Ref: 2024 – WC – SE - 039

Structural Engineering Investigation and Remedial Concepts
to Erf 19018, Seeumeu Park, Mossel bay
House Curtain

Report – Rev 02

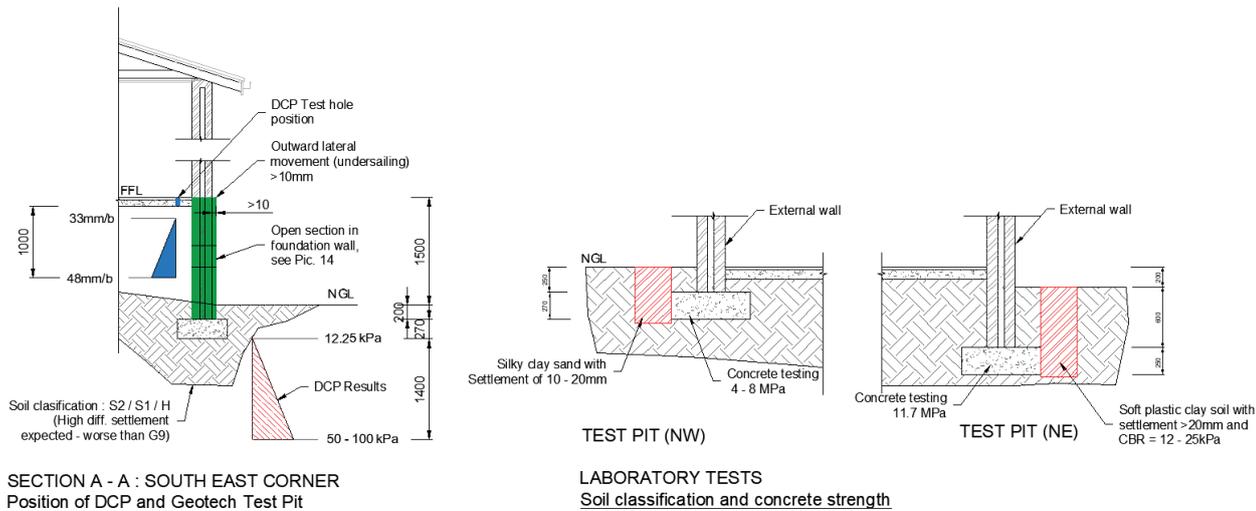
- Soil classification is S2/S1/H1 with potential settlement between 10mm to 20mm
- CBR indicators of fill under surface beds range from 12 to 25 kPa
- Average concrete strength of external strip foundations is 8,1 MPa
- Fill below surface beds has inconsistent compaction (DCP's - 35 mm per blow to more than 80mm per blow)
- Sufficient soil bearing capacity is approximately 1,0m below existing strip foundations.

The images below is a summary of the geotechnical investigation test results and engineering interpretation of the DCP and CBR results, with graphical illustrations for clarity.

3.1 Activity 1 & 2: Foundation - Concrete underpinning and Strengthening off walls

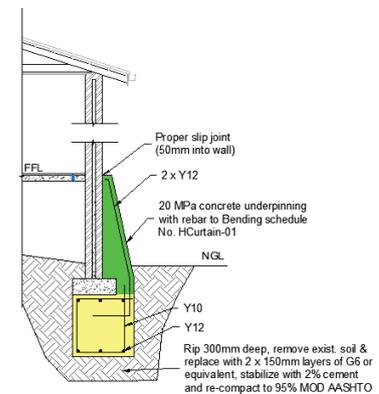
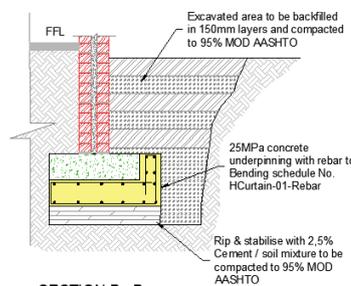
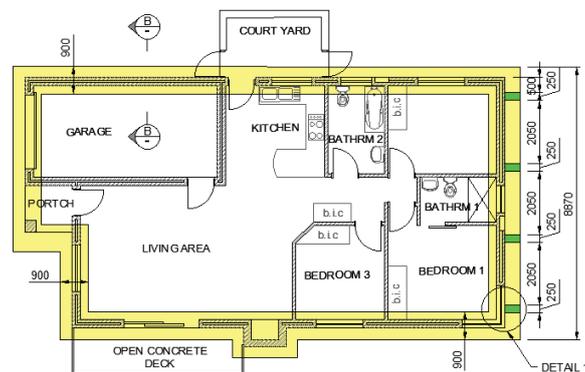
The geotechnical investigation conducted by **Terra Geotechnical (October 2024)** as per the report attached as **Annexure F**, revealed unsuitable soil conditions for erection of a structure with **classification S2/S1/H**. Poor concrete strength results of the external strip footings is an alarming factor to possible future severe structural defects and failure.

Concrete underpinning to the existing poor quality strip foundations on the exterior of the structure, with stabilisation of the sub-strata earthworks are recommended, however, the internal wall foundation pose to be problematic in the future where settlement and cracks will occur.

Lateral support and strengthening of the eastern foundation walls are recommended as per **Detail 1** of the drawing attached in **Annexure A**.

Detailed concept remedial methodologies are provided on the drawing attached as **Annexure A** with graphic images given below.

3.2 Activity 3: Stormwater Management – Concrete Aprons

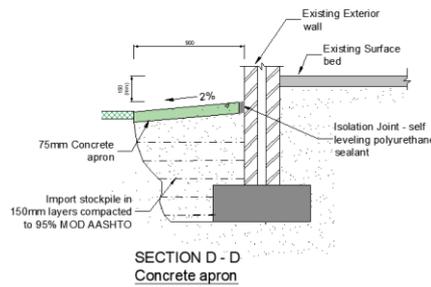
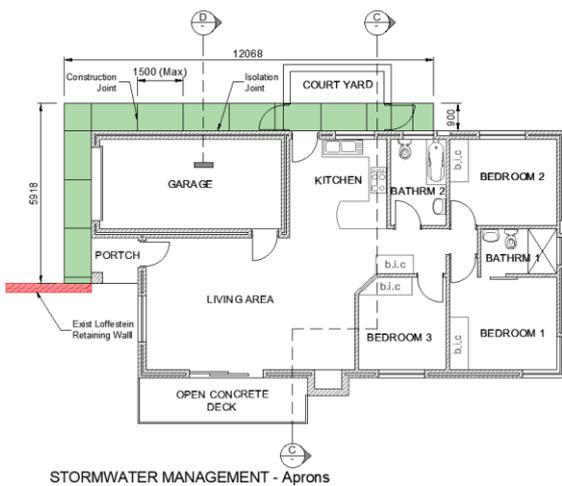
The property site slopes naturally from north to south adequately so to ensure good run-off of stormwater from the structure walls and prevent standing of rain water. However, SANS 10400 – K, clause 4.5.3.7 requires that at least 150mm be maintained between NGL and FFL of a structure, which is not evident on the north and north-east facades of the structure.

Concrete aprons, min 75mm thick of Class 15/19 concrete is recommended to the above-mentioned sections of the building to be the finishing works to the concrete underpinning.

The images below provide information towards the above methodology with full details on the drawing attached as **Annexure A**.

3.3 Activity 4 (Option 1): Crack repair

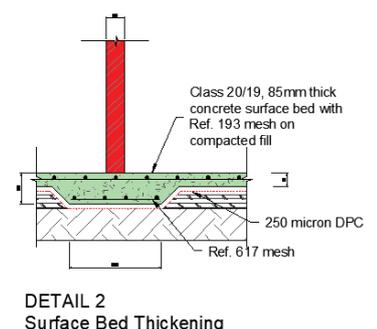
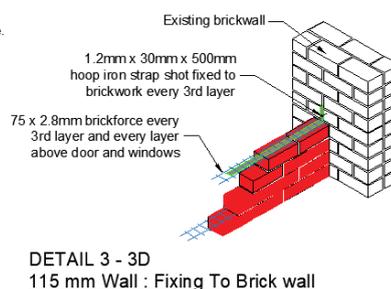
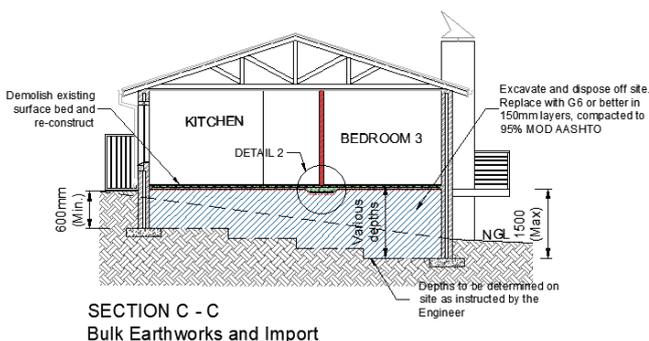
NOTE: Provision to be made to attend to all ceiling skirtings so damaged due to the movement of the walls following the settlement of the surface beds, eminent from the structural cracks on the walls.

Repair structural cracks on all walls according to Detail 4 (Expanded metal lath) as per the image below.
